Re: Final Subdivision - Sawmill Court
Westtown Township – SD-02-21-16633

A Final Subdivision Plan entitled "Sawmill Court", prepared by Inland Design, LLC, and dated December 7, 2020, and last revised February 10, 2021, was received by this office on March 8, 2021. This plan is reviewed by the Chester County Planning Commission in accord with the provisions of Section 502 of the Pennsylvania Municipalities Planning Code. We offer the following comments on the proposed subdivision for your consideration.

Site Plan Detail, Sheet 4: Final Subdivision - Sawmill Court

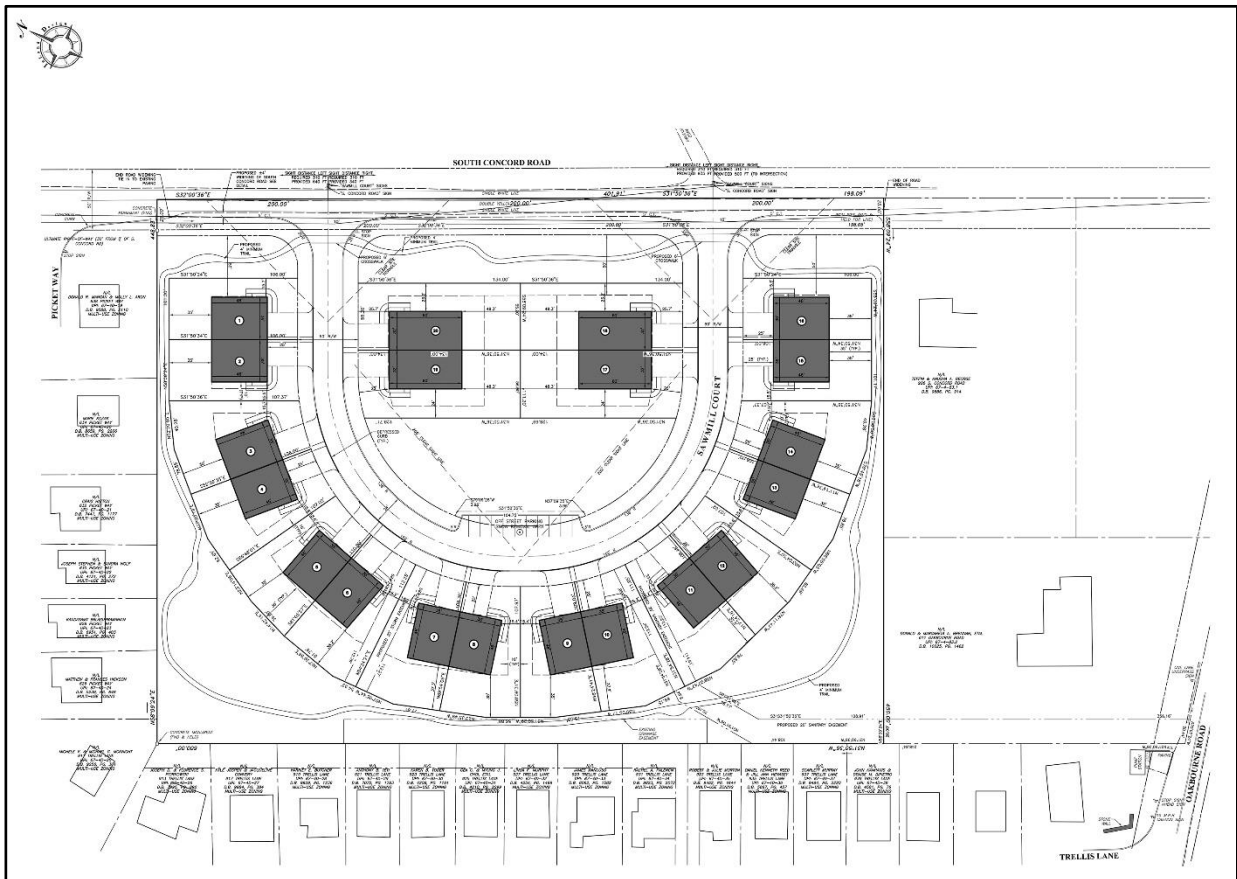
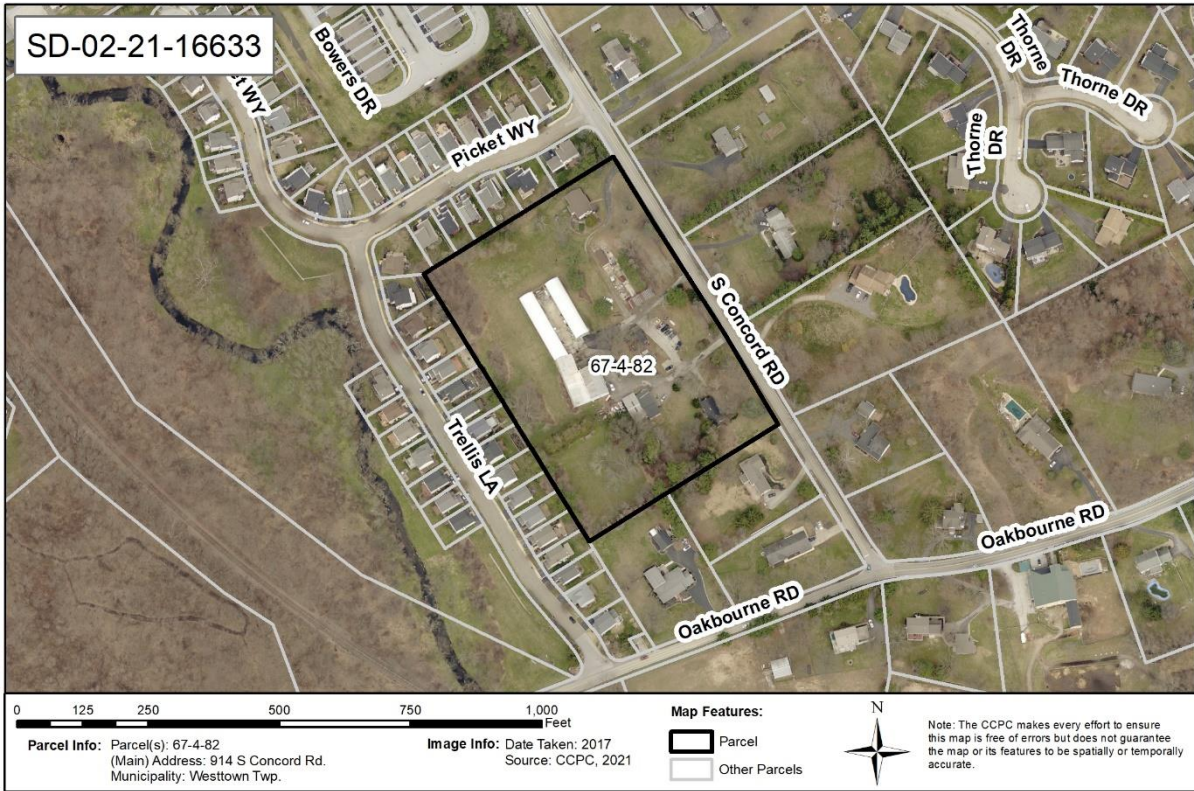
3. Traffic Note 6 on Sheet 4 states that there are no sidewalks proposed along Sawmill Court. We recommend that sidewalks be provided along Sawmill Court. Sidewalks are an essential design element for new construction in the **Suburban Landscape**.
4. The site plan depicts the location of a walking trail around the perimeter of the site within the open space areas (a walking trail section detail is provided on Sheet 17). We also note that crosswalks will be provided. We recommend that, instead of the meandering trail along South Concord Road, the applicant and Township provide sidewalks and crosswalk areas along South Concord Road that extend to the adjoining parcels to the north and to the south, and link the walking trail to this sidewalk.

All trail corridor location and design details should be incorporated into the final plan, and we also recommend that any trails be constructed prior to the Township issuing any building occupancy permits for this development.

5. While we acknowledge that a subsurface infiltration basin will be provided in the central open space area (Open Space 'A'), we recommend that the applicant and Township consider providing community facilities, such as a tot lot or gazebo, within this open space area, to serve the residents of this subdivision.

6. We commend the layout of the townhomes along South Concord Road for having its primary entrance facing this public street. We recommend that the applicant treat these units with dual porches or wraparound porches on the front and side facades so they engage both street frontages in a pedestrian friendly manner.

7. We recommend that the applicant provide at least two variations in building design, such as changes in floor plans, fenestration patterns, facade articulation, and roof form. We also encourage variety in garage placements to deemphasize garage doors, and avoid garages dominating the streetscape and the front of the homes.

8. A site plan note on Sheet 4 appears to indicate that the nine off-street parking spaces located on the south side of the central open space area will also be utilized as a snow removal area. If this is correct, then we suggest that the applicant and Township investigate the feasibility of providing separate designated snow disposal area(s) on this site. Designated parking areas should not be utilized for snow disposal.

10. The site plan depicts the location of stormwater, sanitary, drainage, and snow removal easements. The details of these easements should be incorporated into the deeds of the affected lots.
